INDUSTRIAL WATER LICENCE INSPECTION REPORT

INDOS	TIMAL WATER LICE	NCE MOI ECT			
Date: April 15-16, 2014	Licensee Rep. (Name/Tit	le): Tyler Myers, E	nvironme	ental Superintendent	
Licensee: Baffinland Iron	Mines Corporation	Licence No.: 2	AM-MRY	/1325	
A compliance inspection was Aboriginal Affairs and North Corporation (BIMC) Mary I	hern Development Canad	a (AANDC) for the	Baffinlan	d Iron Mines	
Source(s): Lake KM32 (M (Mary River Camp)	ilne Camp), Camp Lake	Quantity used: N	N/I		
Indicate: A - Acc	ceptable U - Unacceptabl	e NA - Not Applic	able NI	- Not Inspected	
Intake Facilities: U	Storage Structure: NI	Treatment Syste	ms: NI	Chemical Storage: NI	
Flow Meas. Device: NI	Conveyance Lines: NI	Pumping Station	ns: NI	Screen : NI	
River site, water is whereas, at the M using a Water True • At the Km 32 Lake located next to the equipment (see Fi		and piped directly mped directly from me ice and withdra ipment, a Terex Lithe winter to provwithin 31m of the licence.	y to the M n Km 32 L ws water ght Plant ide light a e high wat Vaste Wa Vaste Wa Treatmen	Mary River camp; ake for use at Milne Inlet on an as needed basis. and a seacan were and the storage of ter mark and must be ter Tr

Figure 5: Improperly stored hazardous waste located outside an approved hazardous waste storage facility.

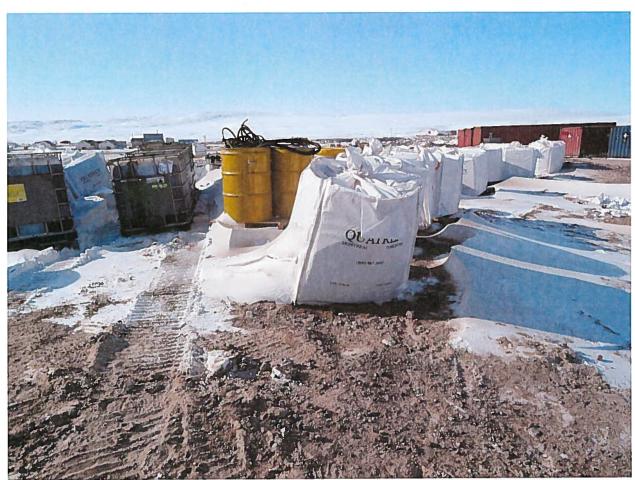
- Hazardous waste berm (Milne Inlet) N71° 19′ 53″.01, W80° 53′ 48″.81.
 - o It was noted that some hazardous materials were situated outside the bermed area and a spill was noted coming from one of the Megabags located outside the berm (see Photo 5).

- O As per the Materials and Hazardous Waste Management Plan, 2013, all hazardous waste are to be in lined and bermed facilities.
- Fuel Storage and Transfer Area
